Access Compliance Report

Public Rights-of-Way

(Curb Ramps)

Intersection ID: 52125	Main Street: ROZZELLES_FERRY_RD	Cross Street: VALLEYDALE_RD	Location: E
ADA ID: 61906A461078	Ramp Type: Perp	Initial Pass/Fail: Pass	Overall Compliance: No
Severity Score: 2.75			
Codes/Mitigation Info/Possible Solution		Field Measurements/Component Compliance

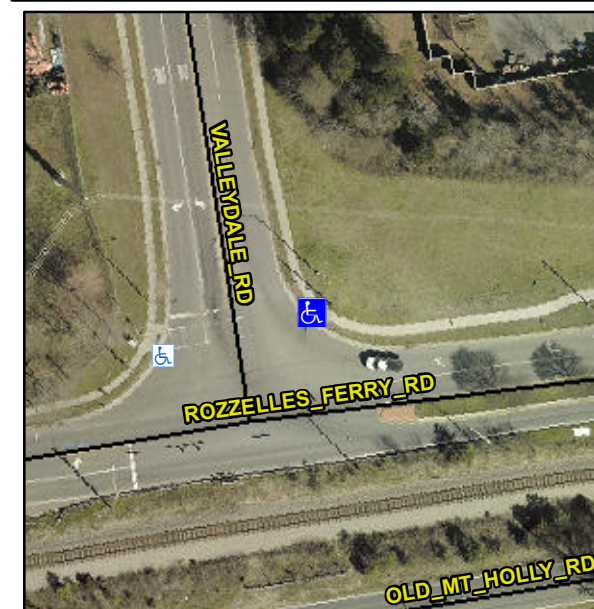
Remove & Replace Entire Ramp.

Not Found, R304.2.2-Perp, R304.3.2-Para, R305.1.4, R305.2
